Subject: Post-Closure Modification Notice to Proceed for the Applebys Auto Salvage site,
W2578 Holland-Lima Road, Oostburg, WI
Parcel # 59008102920
BRRTS # 03-60-305128

June 3, 2022
Michael Thun, Harter's Lakeside Disposal LLC
Post-Closure Modification Notice to Proceed
Applebys Auto Salvage - BRRTS # 03-60-305128

Attachment: Figure 1, Proposed Facility Site Plan with Residual Soil and Groundwater Contamination, 4/11/2022

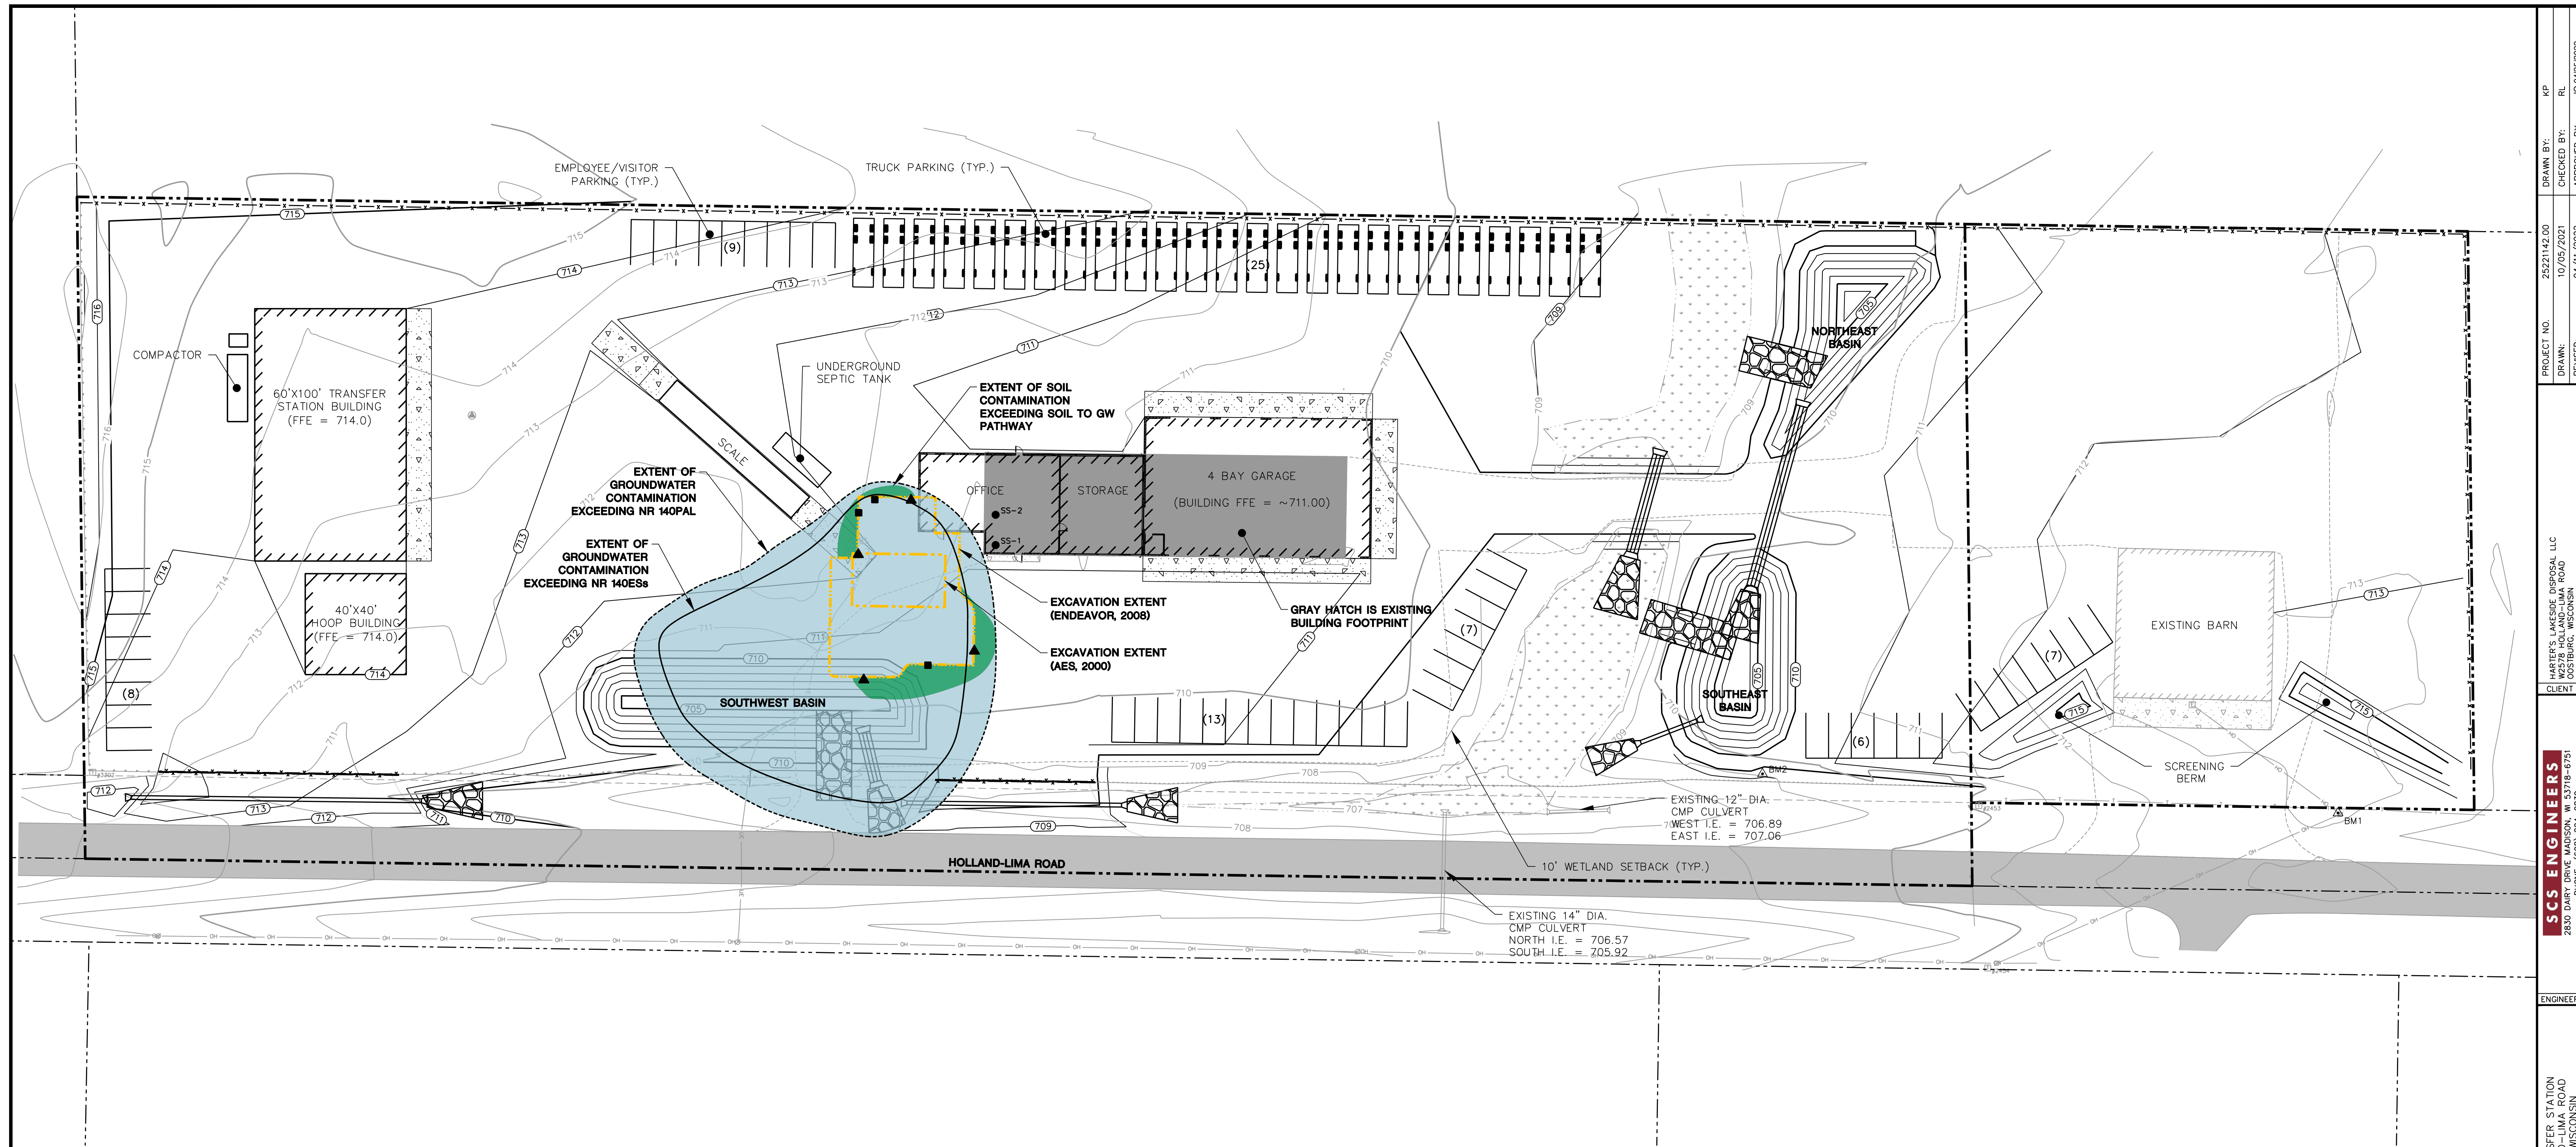
- If the existing building is expanded to the west further encroaching on the residual contamination for the construction of office space, additional sub-slab vapor sampling would be required to evaluate the potential for vapor intrusion into an occupied building. A minimum of two sub-slab vapor sampling events will be required including a sampling event during the heating season.

- If possible, consider relocating the western storm water pond outside the footprint of residual soil and groundwater contamination. The reasoning would be to minimize the possibility for any water from the storm water pond potentially coming in contact with the residual contamination present at the proposed location.

- The historic monitoring well MW3 was not properly filled and sealed at time of case closure in 2017 as the environmental consultant was unable to locate the well. If encountered during the proposed construction activities, monitoring well MW3 should be properly abandoned and documentation should be provided to DNR.

- If future utilities intersect the area of residual contamination, utility plugs should be considered to minimize potential contaminant migration.
